TOWN OF PLAINFIELD PLAN COMMISSION REPORT

CASE NO.: [RZ-24-019](#)

PETITIONER: Huber & Son Construction LLC *(represented by Ben Comer, Comer Law)*

REQUESTED ACTIONS: Zone Map Amendment from AG: Agriculture to GC: General Commercial

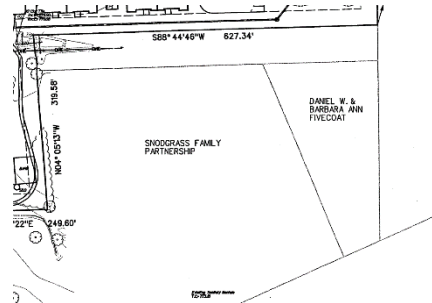
The site is bordered on the north by a parcel of land that is zoned Saratoga PUD but appears to not be a part of that Planned Unit Development. The 2002 primary plat for the Saratoga Springs condominiums does not include this northern parcel (see right). This northern parcel and parcel to the west were owned by the Snodgrass Family Partnership until 2016 when they were purchased by Javier Moreno Arriaga.
